Final Environmental Impact Statement (FEIS)  
Country Courses at Kahuku  
Malaekahana Course (Campbell Estate)  
Tax Map Key: 5-6-06: 2 and Portion of 6

1990-Oahu - FEIS -  
Country Courses FILE COPY  
Malaekahana I

**COUNTRY COURSES  
AT KAHUKU**

**Malaekahana**

Figure 2. Malaekahana

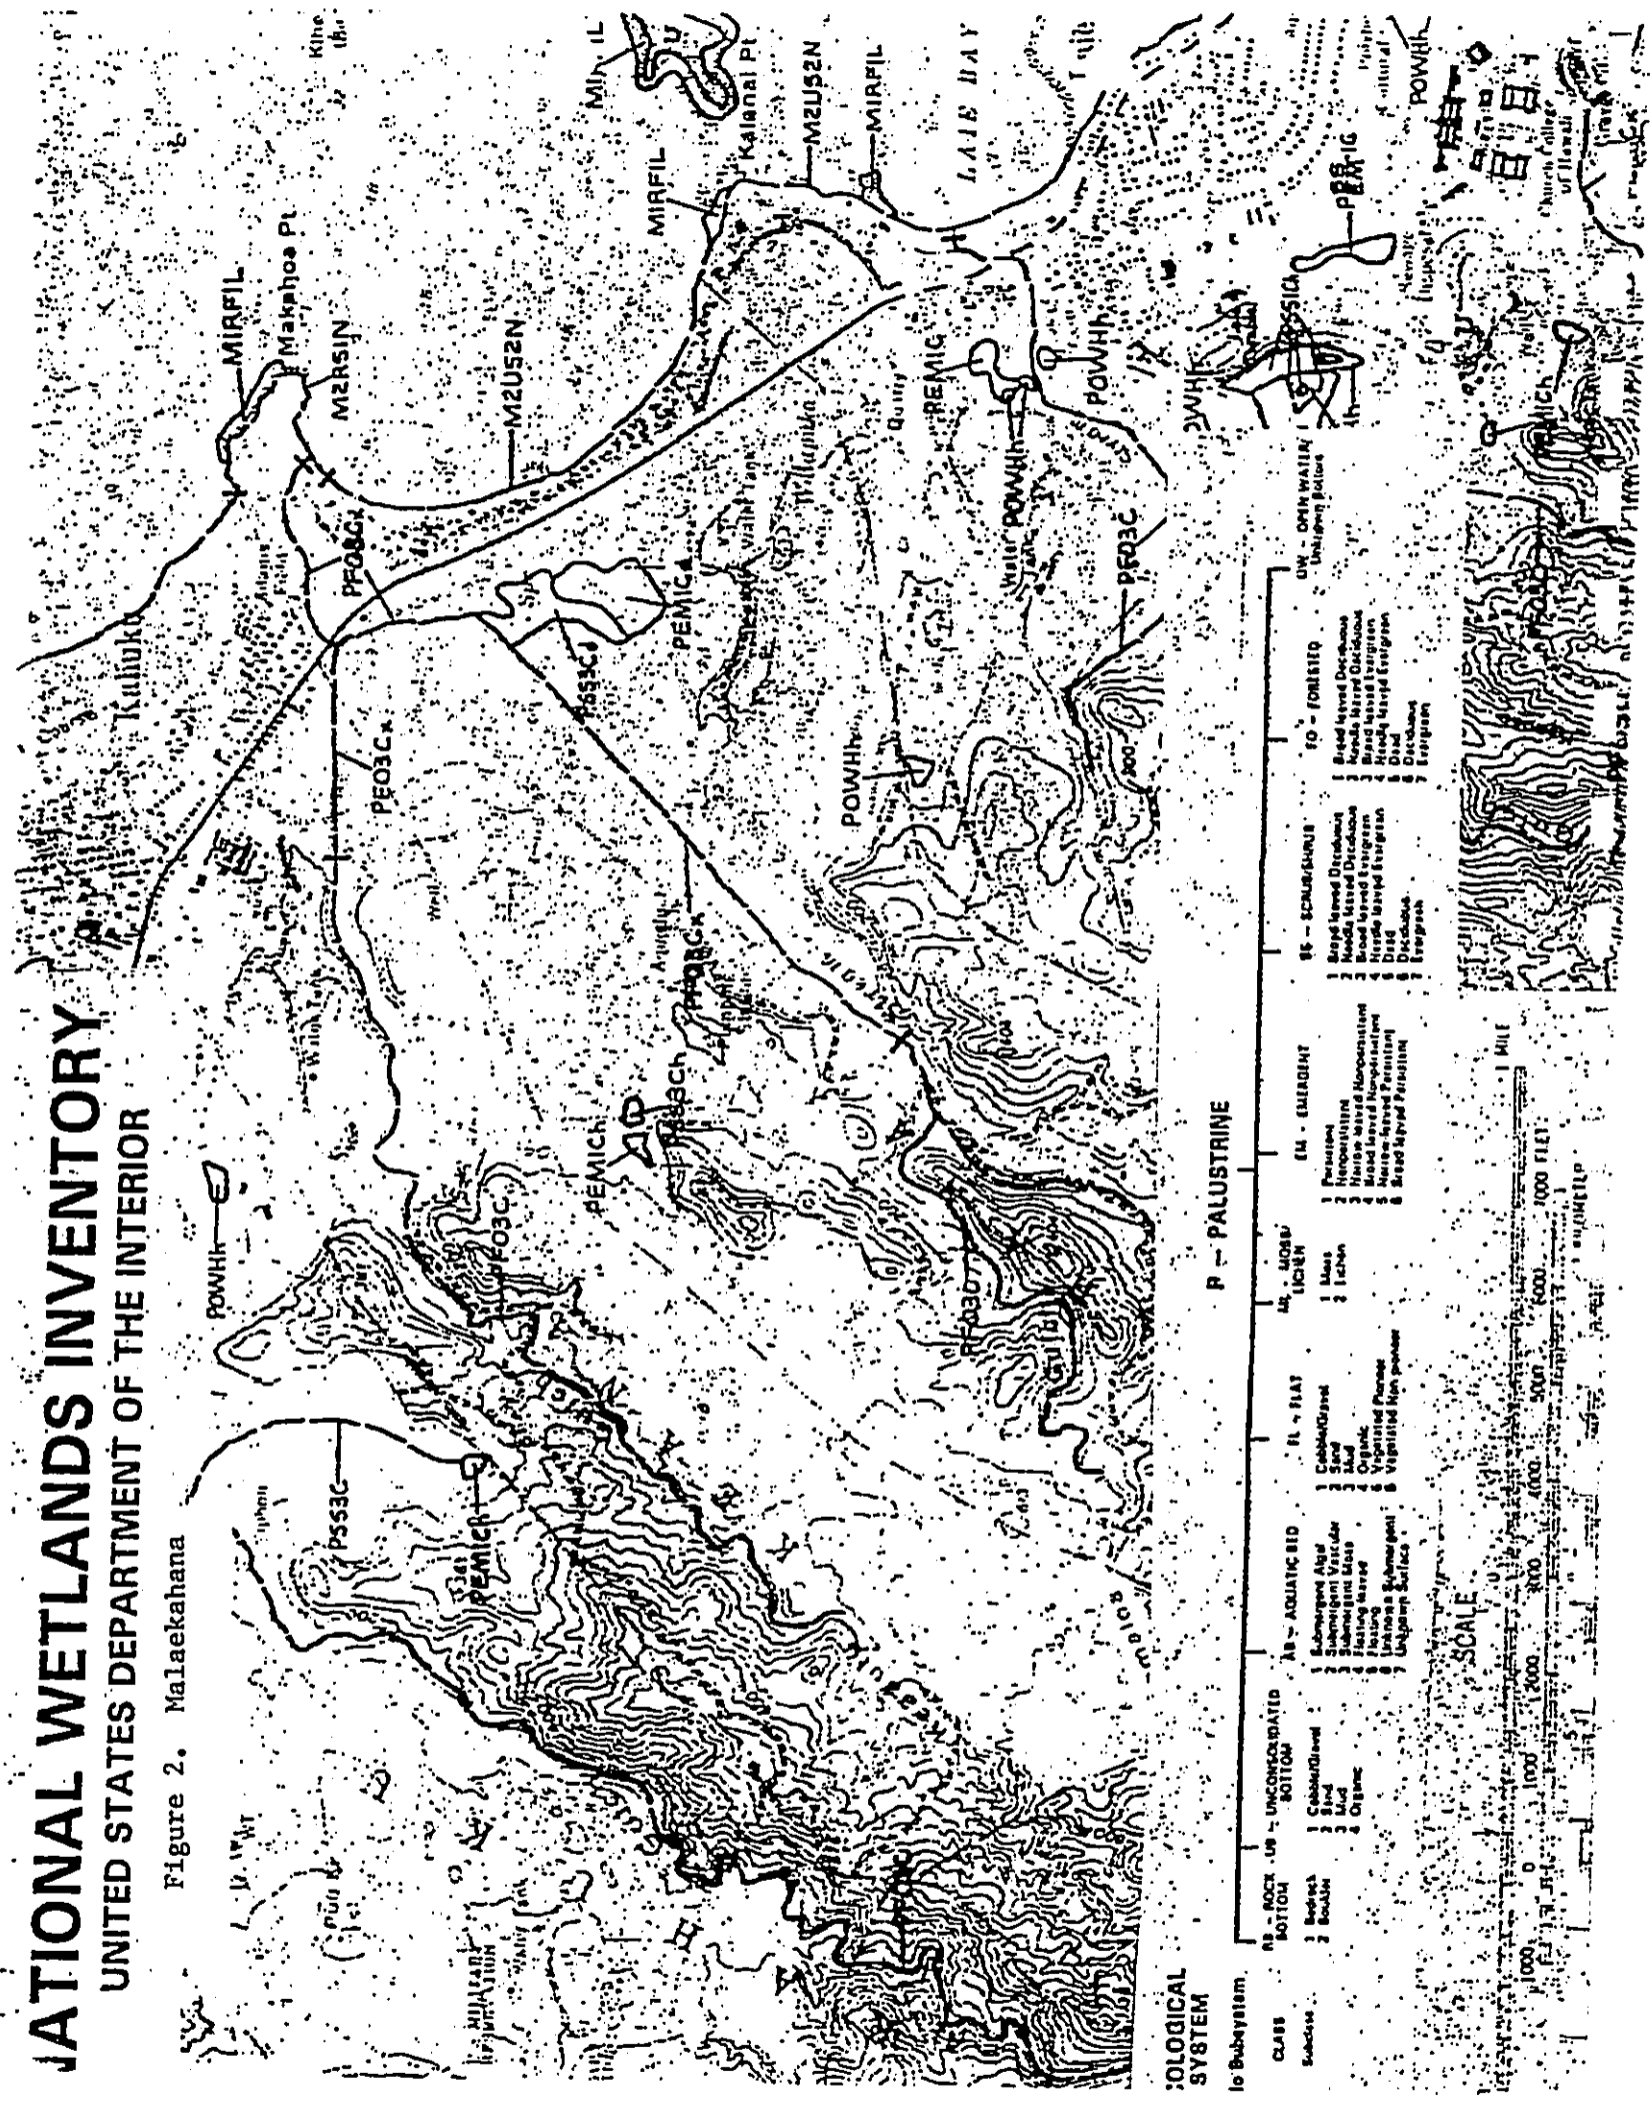
The wetlands located within the Kahuku and Malaekahana drainage basins provide habitat for the four species of endangered Hawaiian waterbirds, and for migratory shorebirds and waterfowl (Figures 1 and 2). The Punahoolapa Marsh and the James Campbell National Wildlife Refuge (NWR) at Punamano and Kii are particularly important wetlands in the Kahuku basin for endangered Hawaiian waterbirds and migratory shorebirds and waterfowl. While the wetlands at the Kahuku and Malaekahana sites would not be directly impacted by the construction of the golf courses, secondary impacts to wetland habitats and endangered waterbirds may occur from the operation of the proposed golf courses. These secondary impacts include the potential run-off and drift of pesticides from the golf courses into the refuge and other wetlands, increased nutrient and pesticide levels in the groundwater that support these wetlands, modification of wetland hydrology from the withdrawal of groundwater and from the alteration of surface drainage patterns, and potential poisoning of endangered waterbirds and migratory birds foraging in the water hazards and golf greens.

FIG. 6  
\*\*

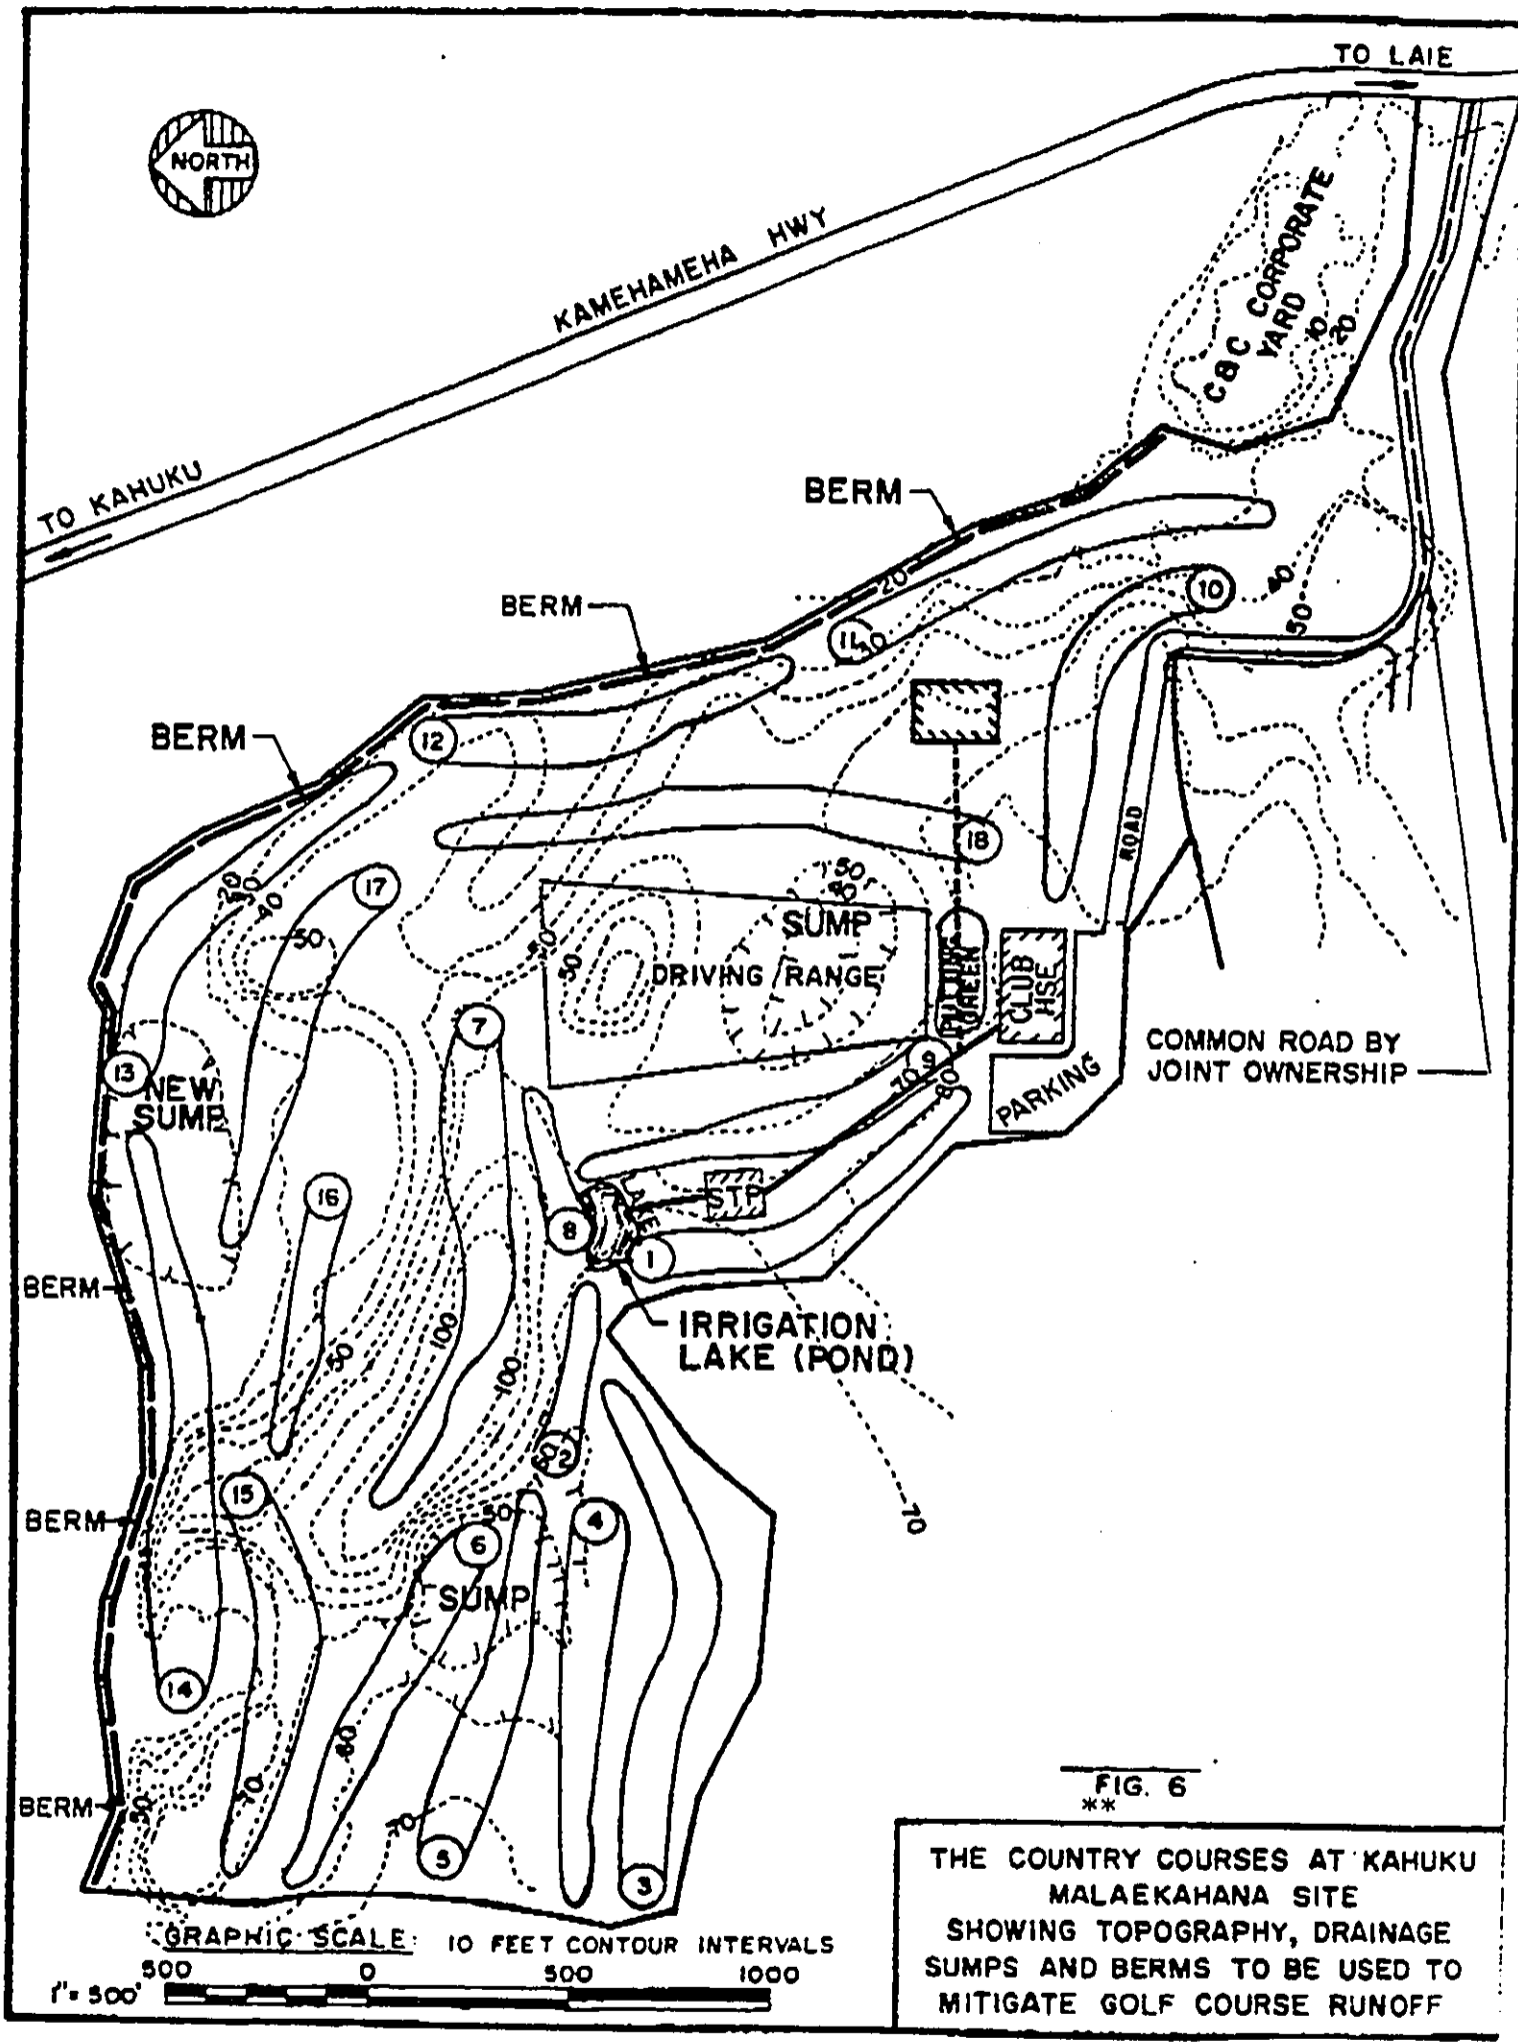
1. The Draft EIS (Volume I, Figure 13, Photo J) shows "aquacultural ponds just beyond northwest end of site." Information regarding the distance of these ponds from the project boundary, ownership and operation of these ponds, as well as the potential impacts of the proposed golf course operations on these ponds should be included in the Final EIS.

The aquacultural ponds shown in Photo J, Figure 13, Vol I are located on the northwest boundary of the project site on 48.9 acres of land. (See attached map) The area is leased to the Kahuku Prawn Company by Campbell Estate. Kahuku Prawn Co., which was established in 1979, is a profitable operation which generates revenues of up to \$500,000 per year from production of up to 75,000 pounds of prawns per year, and employs 10 people. The current lease expires in 1991, and a 10-year extension is under negotiation. The availability of land for the prawn operation and the terms of the new lease or any subsequent lease would be unaffected by the existence of the golf course.

A berm will be constructed along the east and north boundary of the site to contain the runoff and to direct much of it to the sump shown on Figure 6 (attached). It should also be noted from the contours provided on the site layout that runoff from the golf course, should any occur, would be to the northeast and not towards the aquaculture ponds which are located in and along Malaekahana Stream to the northwest of the site.
